VILLAGE OF FRIENDSHIP HEIGHTS

Re: 5500 Wisconsin Ave. Development Sketch Plan

Photo No. 3 above: 15 story Highland House Apartment house occupying an entire block of S. Park. Ave. The proposed new building will occupy the entire block of the opposite side of the street.

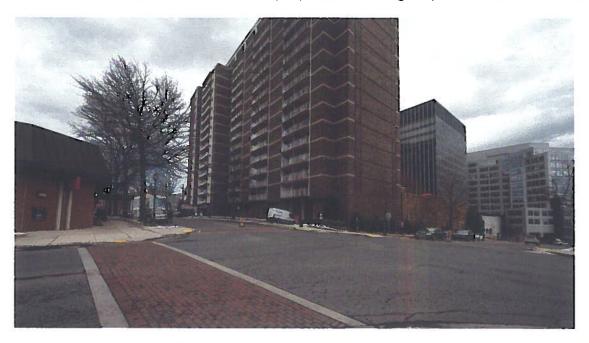
4. Additional adverse consequences from such a tall building arise from the fact that the building confronts the Highland House apartments on the opposite side of the relatively narrow S. Park Ave. The 15 stories of apartments in the Highland House will look directly into the 18 stories of the proposed building's apartments and vice versa.

Further, the height of the proposed building confronting a 15 story building will "canyonize" the street, affecting not only views but reducing light on the entire block of S. Park Ave. and otherwise making it aesthetically unattractive. The Village already experiences the negative effects of such "canyonization" (see photo No. 4 below.) Its main internal street, N. Park Ave, is lined with high rises, blocking open space, views from dwelling units, sun, light, air, making the street not an aesthetically pleasing one. As discussed below, a principal purpose of the Sector Plan is to preclude the recreation of such conditions.
